Project Title  
9860\_District Living Residential Development

### MINISTERIAL PLANNING REFERRAL

<b>City of Melbourne Application number:</b>	TPM-2023-13
<b>Department of Transport and Planning Application number:</b>	PA2302385
<b>Applicant:</b>	AM HT Development No.5 Pty Ltd c/ Tract Consultants Pty Ltd
<b>Owner:</b>	AM HT Development No.5 Pty Ltd
<b>Architect:</b>	Warren and Mahoney
<b>Address:</b>	24 Little Docklands Drive, DOCKLANDS VIC 3008
<b>Proposal:</b>	Buildings and works associated with the construction two mixed use multi-level buildings
<b>Cost of works:</b>	\$240 million
<b>Date received by City of Melbourne:</b>	4 August 2023
<b>Date amended application received by the City of Melbourne</b>	7 February 2024
<b>Responsible officer:</b>	Ciara Cancian, Principal Urban Planner

Figure 20 - Extract from the submitted shadow analysis demonstrating the extent of overshadowing in purple of The Plaza between 1:50pm and 2pm (source: Architectural Plans)

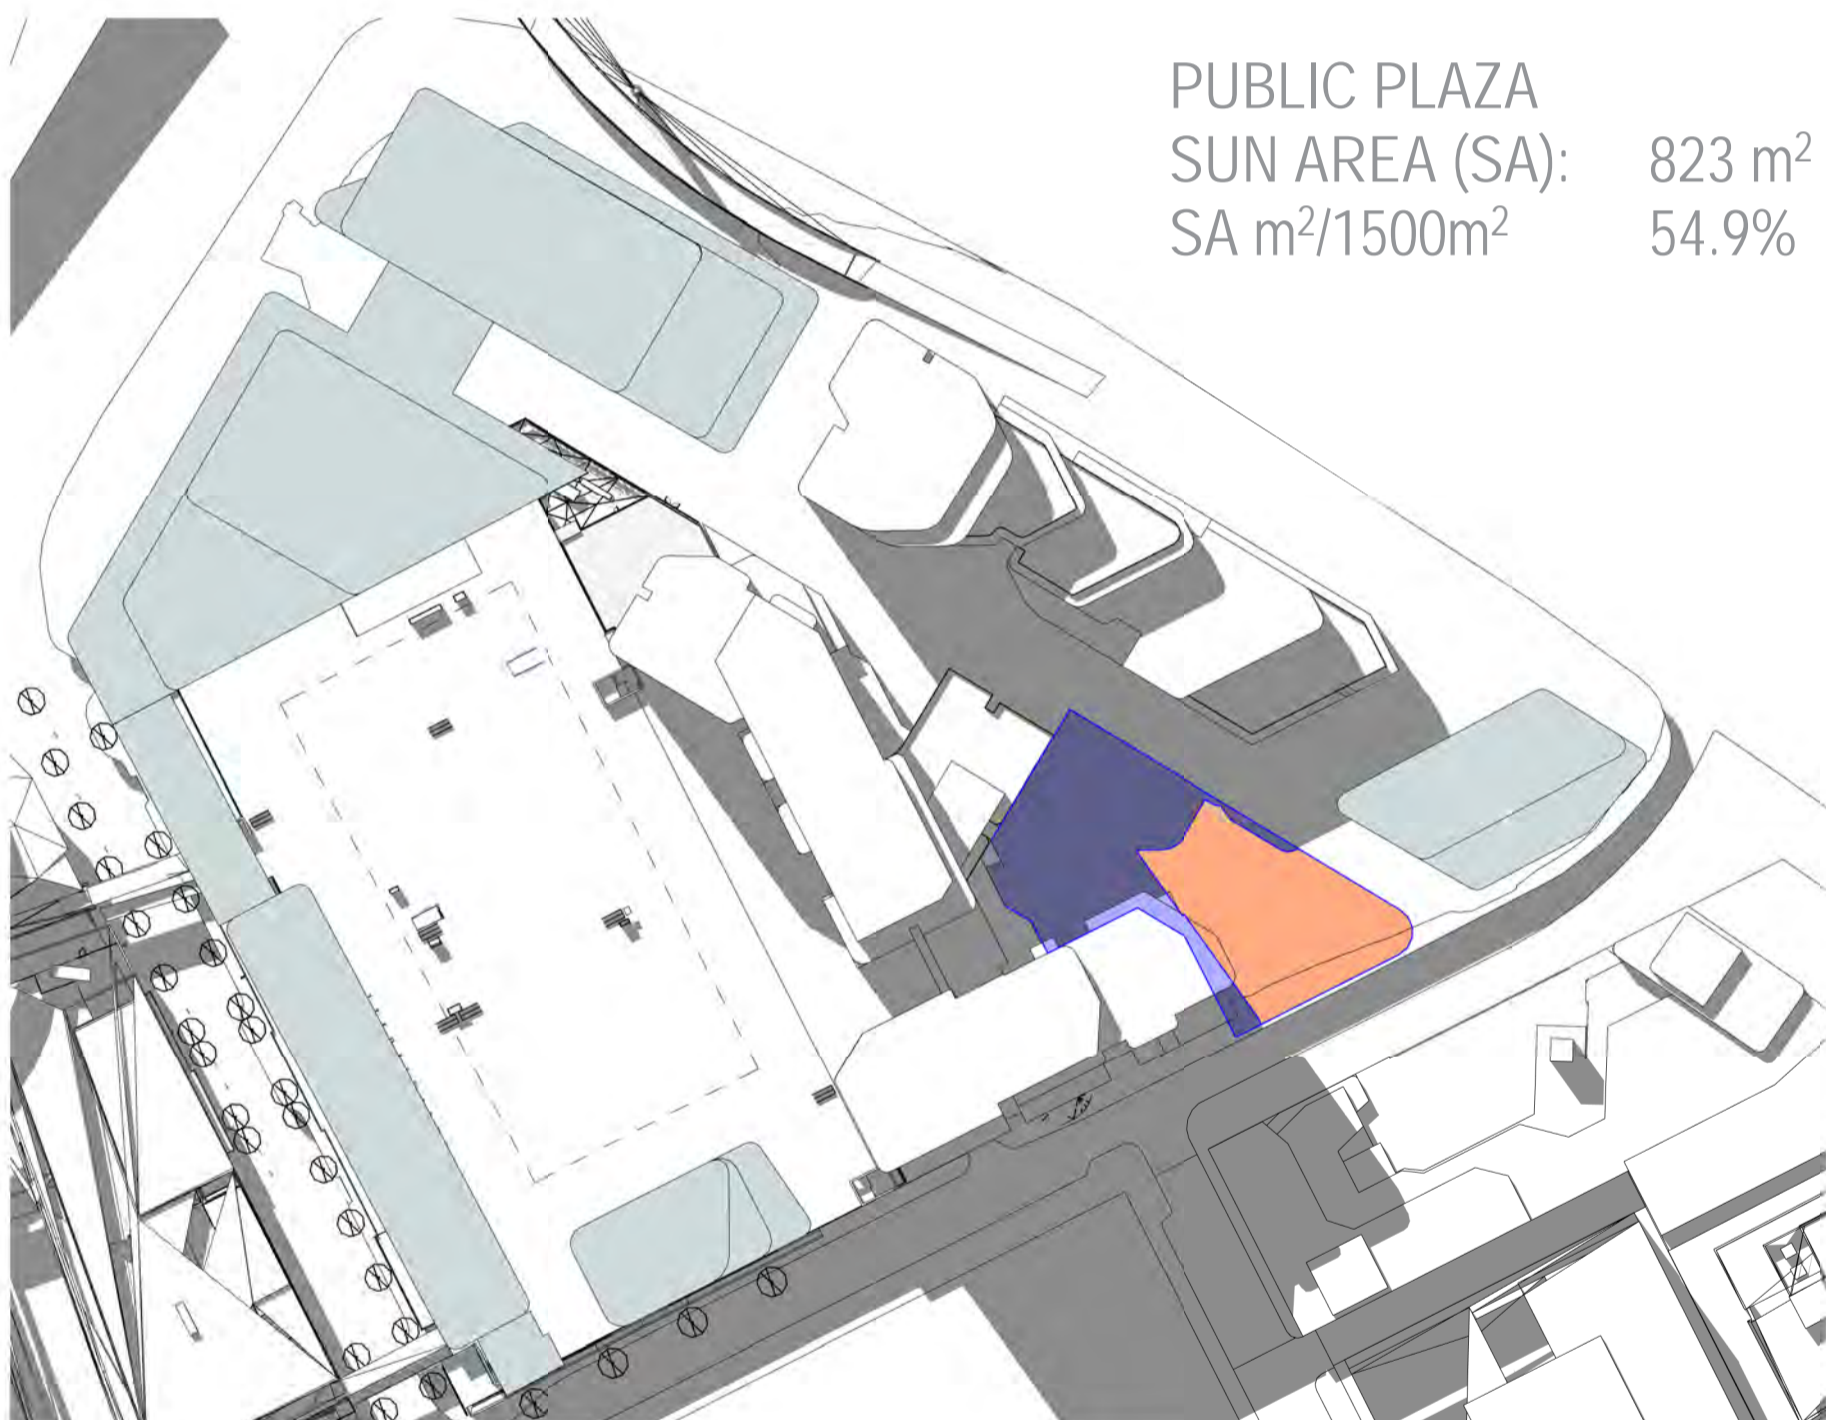
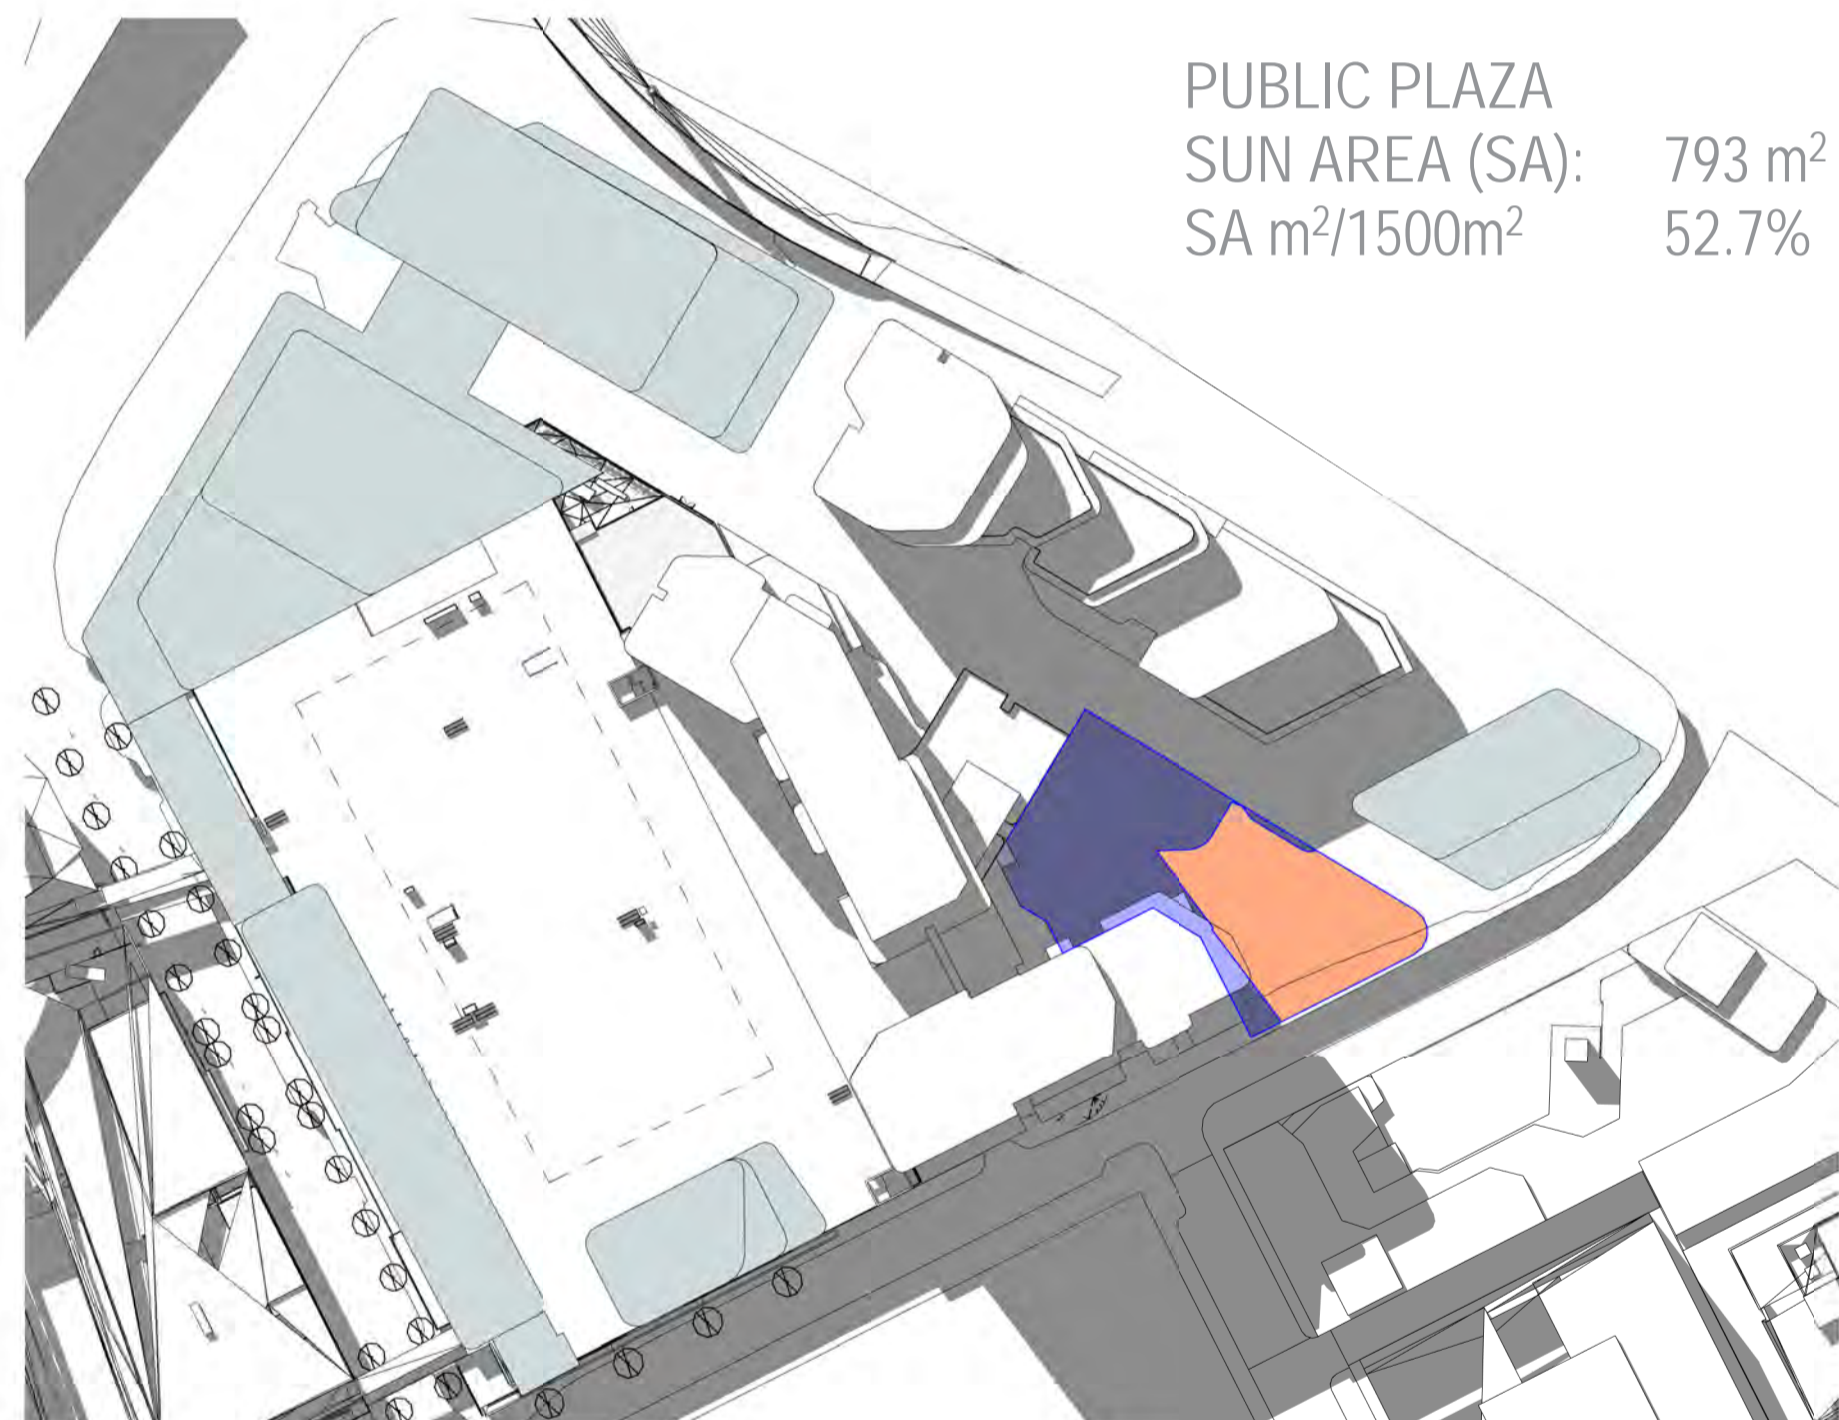
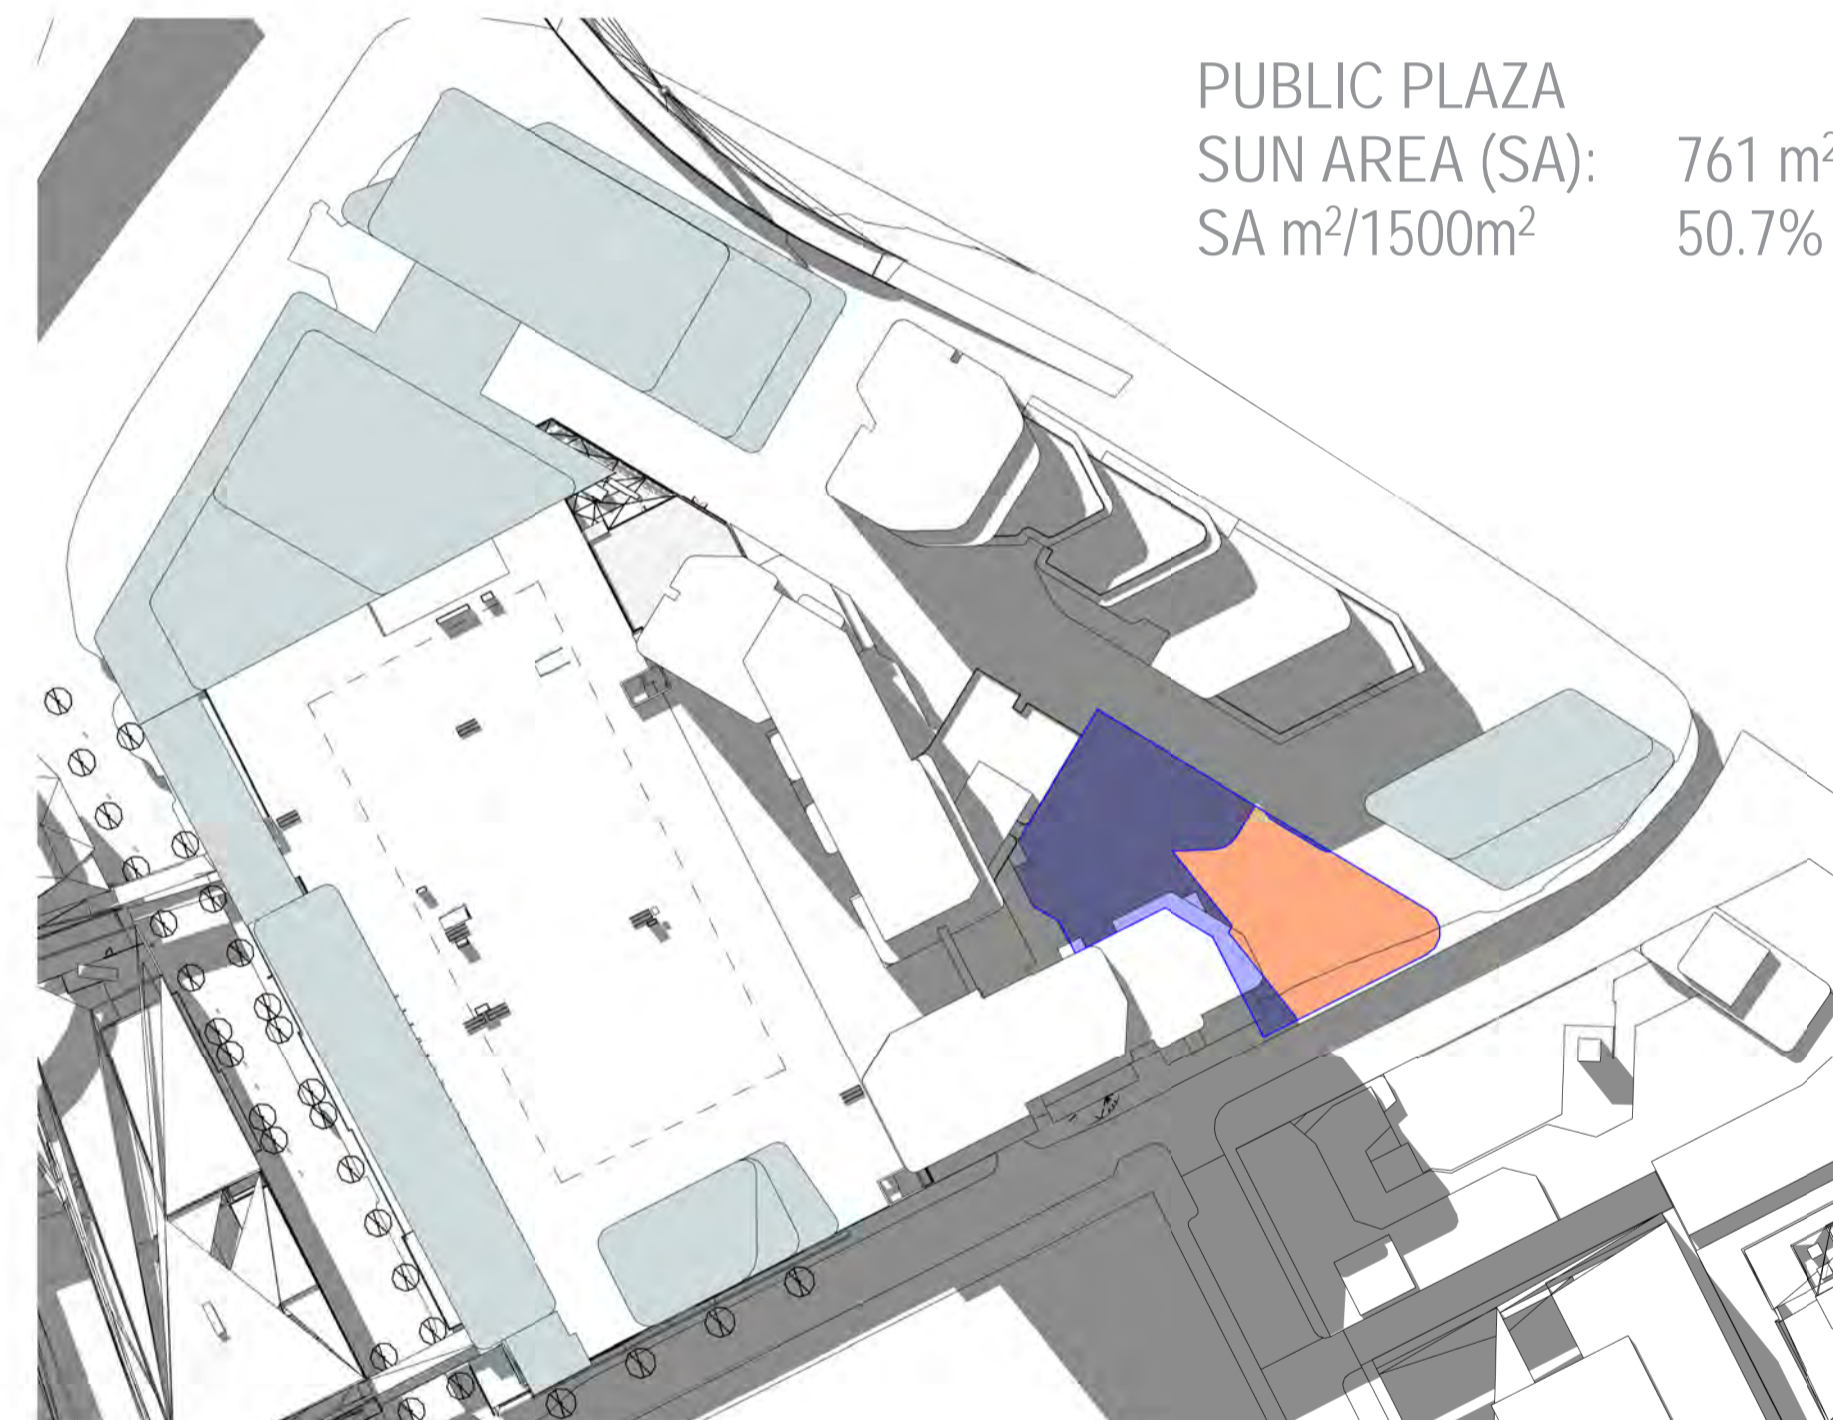
(a 15m<sup>2</sup> variation is required at 1:50pm, 43m<sup>2</sup> at 1:55pm and 73m<sup>2</sup> at 2pm). This variation is demonstrated in **Figure 20** below.
